Access Compliance Report Public Rights-of-Way (Pedestrian Signals)

Main Street: DALE_ST Cross Street: ORANGEWOOD_AVE Location: SW

ADA ID: SGRK210927181652 Signal Type: One Push Button-Non APS Overall Compliance: No Severity Scores: BTN 1: 35 BTN 2: N/A No BTN: N/A

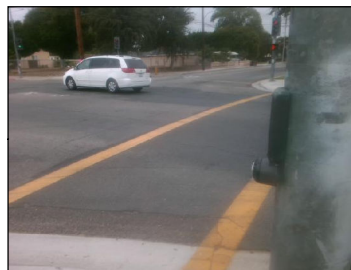
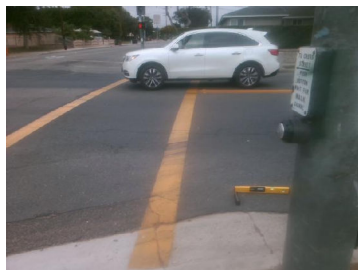
OC Std/PROW: R404.2, MUTCD 4e.08

Possible Solutions: Replace Signal Push Button With APS Button. Remove and Replace Clear Space.
